Planning Application No. A/TM-LTYT/404
Compliance with Approval Conditions (f)

Project:
Proposed Drainage system at Lot 2339 (Part) in D.D.130 (Application No.: A/TM-LTYYY/404)

Title:
 Drainage Proposal:
 Layout

Planning Application No. A/TM-LTYT/448
Compliance with Approval Condition (a)

DD130(2339)-D01

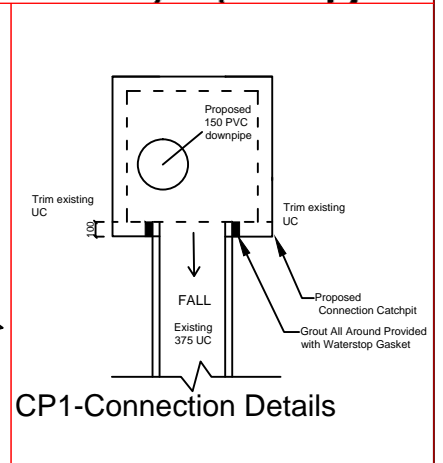
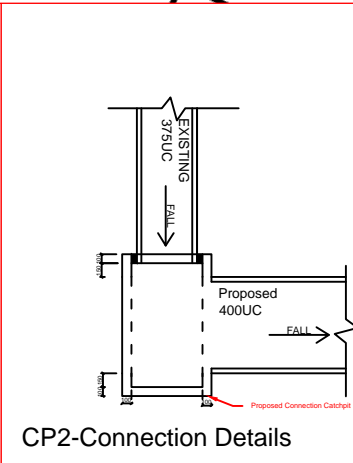
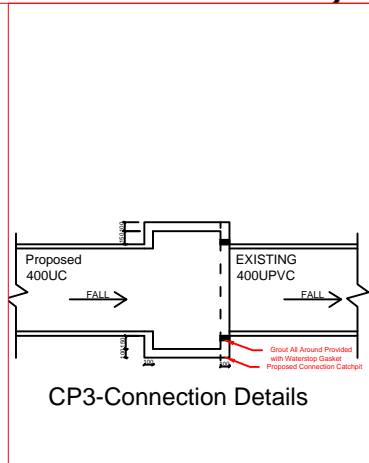
The applicant is reminded to consult, as appropriate, the relevant authorities/owners of the existing drainage for consent of any connection works.
